PLANNING & ZONING COMMISSION WORKSHOP & MEETING THE CITY OF HARKER HEIGHTS WEDNESDAY, JANUARY 6, 2021 – 5:30 P.M. VIA TELECONFERENCE

Minutes of the Teleconference Meeting of the Harker Heights Planning & Zoning Commission December 2, 2020

PLANNING AND ZONING COMMISSION MEMORANDUM

Below is the response to comments for The Village at Nolan Heights Concept Plan, received on November 18, 2020. Response to comment is in **bold**.

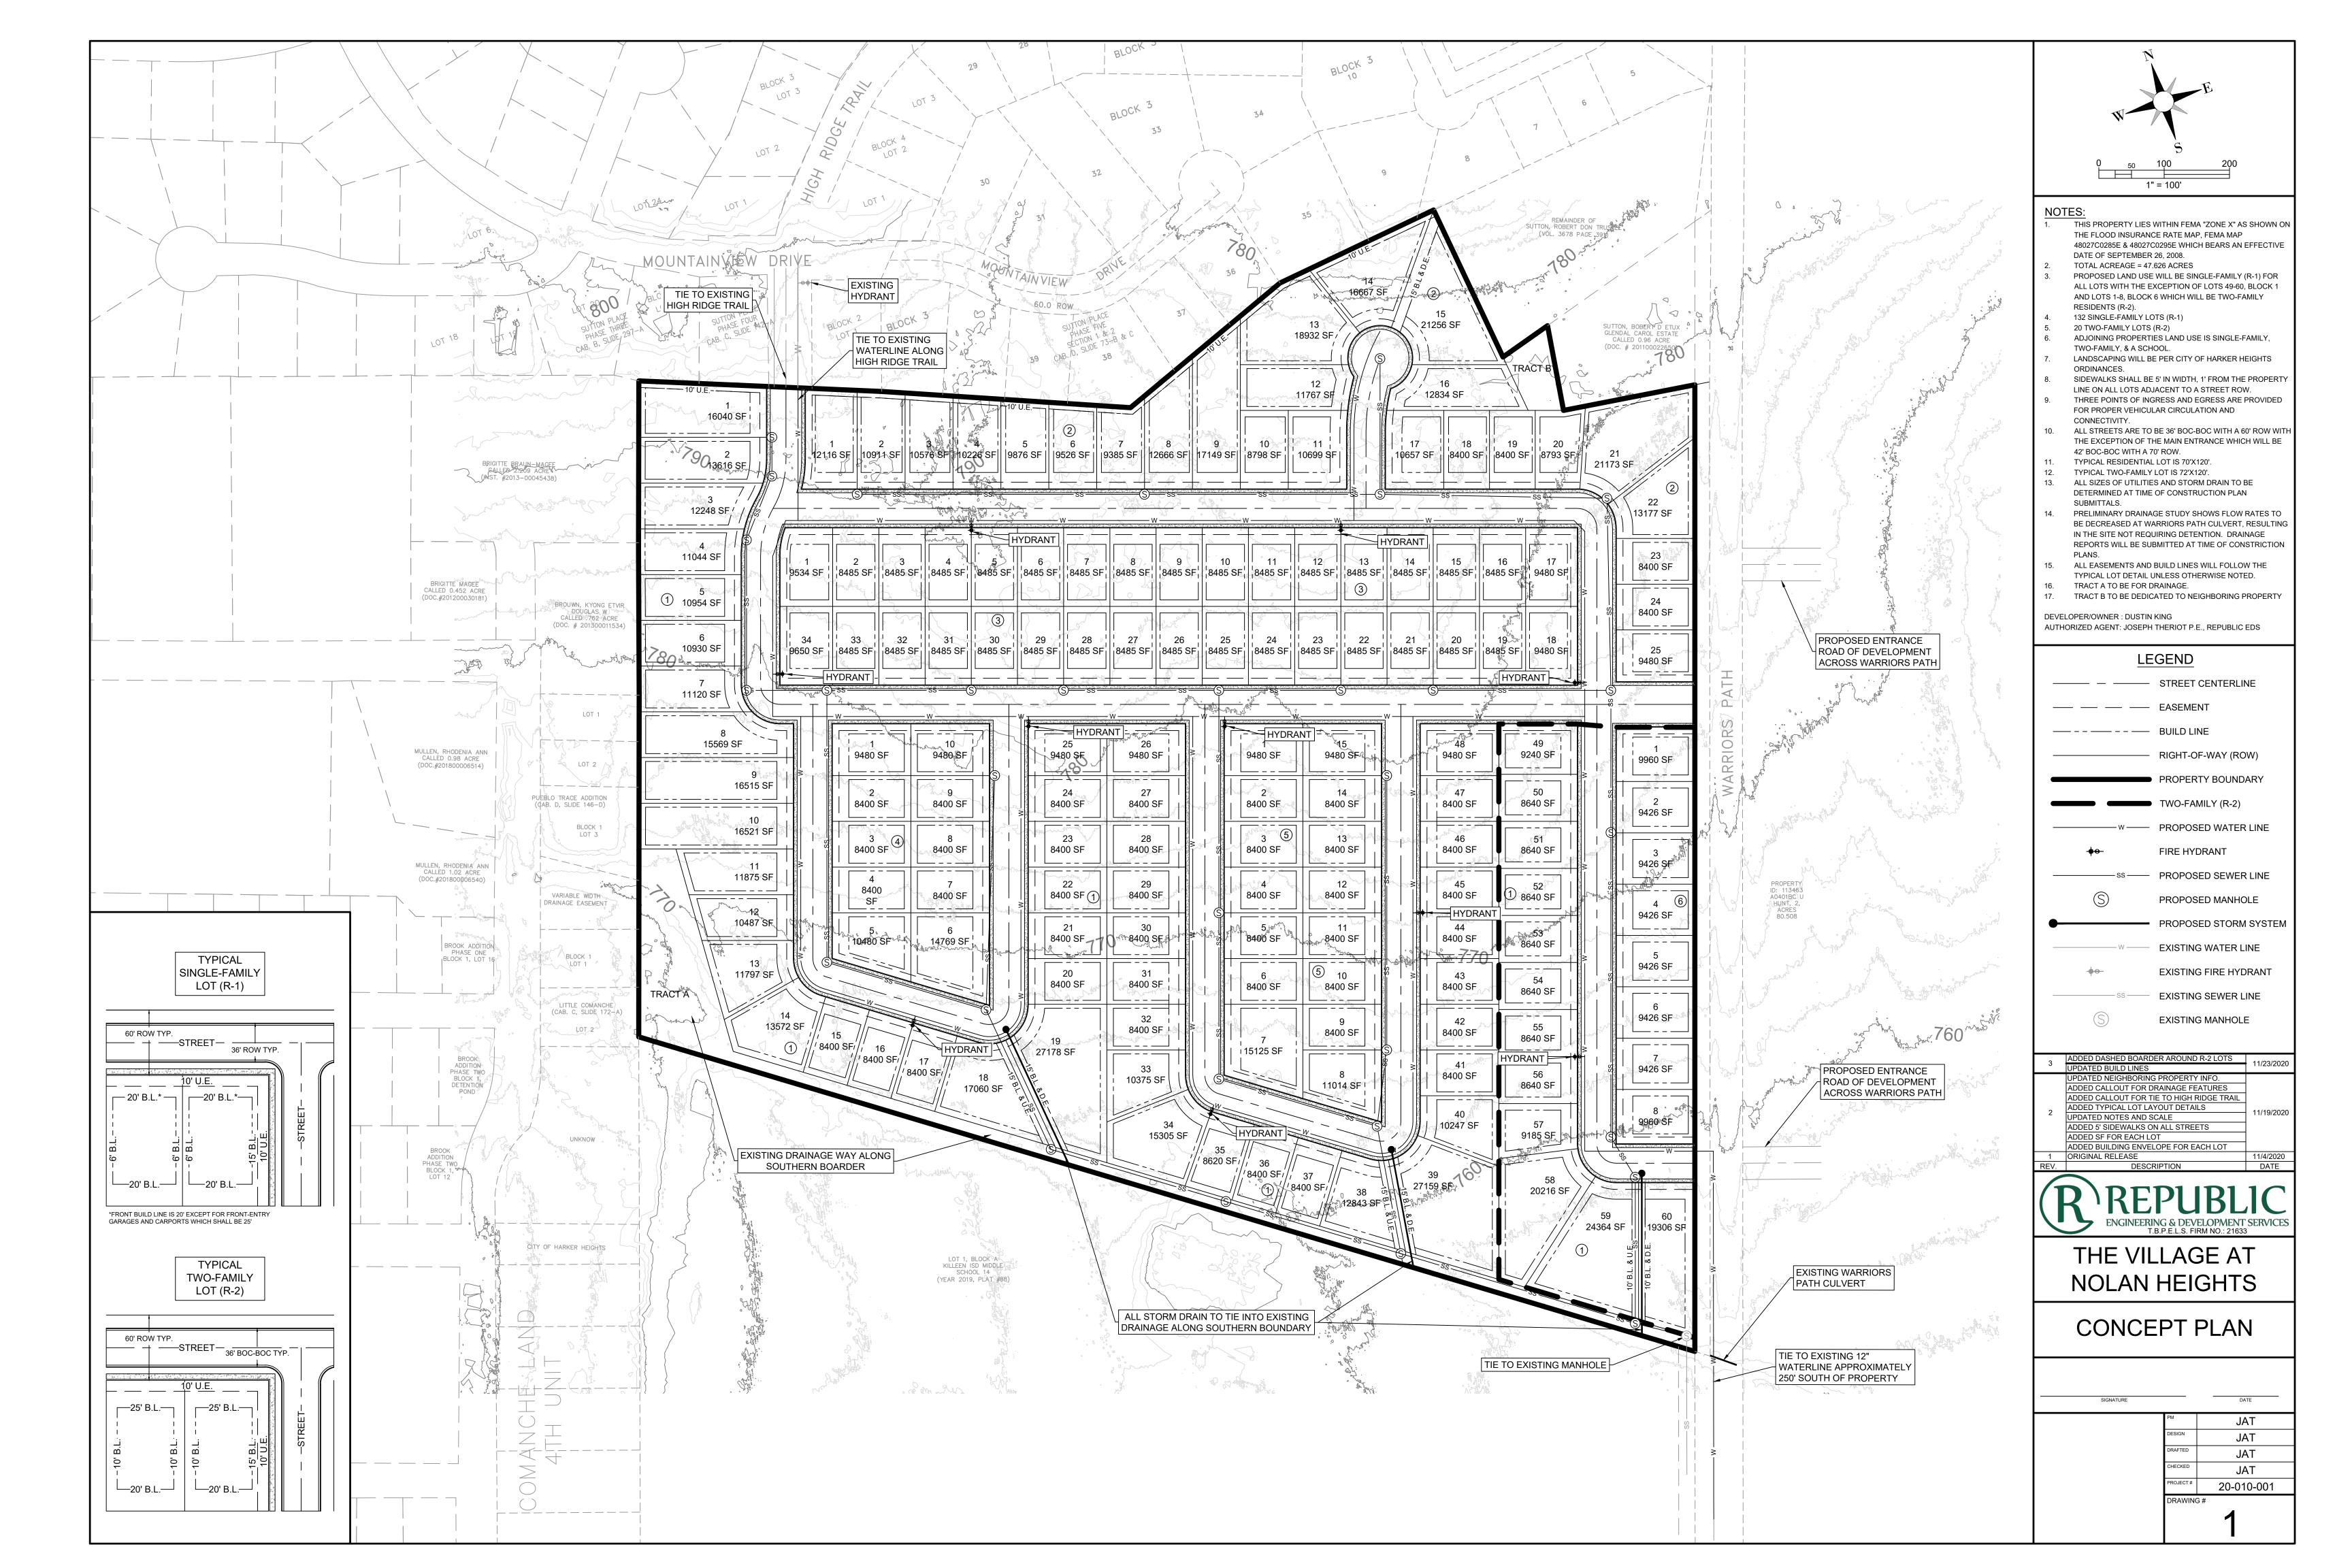
Please provide square footage of lots.
 Square footage has been added for all lots.

- Provide building envelopes on all lots.
 Building envelope has been added for all lots.
- 3. Identify 5' sidewalks within Concept Plan.

Sidewalks have been added to the Concept Plan and the sidewalk note (8) was updated to read "SIDEWALKS SHALL BE 5' IN WIDTH, 1' FROM THE PROPERTY LINE ON ALL LOTS ADJACENT TO A STREET ROW.

Note 3 of the Concept Plan denotes which lots are to be R-1 and R-2. Note reads "PROPOSED LAND USE WILL BE SINGLE-FAMILY (R-1) FOR ALL LOTS WITH THE EXCEPTION OF LOTS 49-60, BLOCK 1 AND LOTS 1-8, BLOCK 6 WHICH WILL BE TWO-FAMILY RESIDENTS (R-2)."

In order to not clutter the drawing, a typical single-family and two-family lot detail was added to the concept plan to show setback and easement widths. On lots that have non-typical setbacks or easements, annotations were added. A note (15) was added to explain, the note reads "ALL EASEMENTS AND BUILD LINES WILL FOLLOW THE TYPICAL LOT DETAIL UNLESS OTHERWISE NOTED."

Notes (2, 4 and 5) were added to the Concept Plan to satisfy this comment.
- 2. Residential streets are required to be 36' wide measured from the back of curb with a 60' wide Right-of-Way.

The street note (10) has been updated in accordance with this comment.
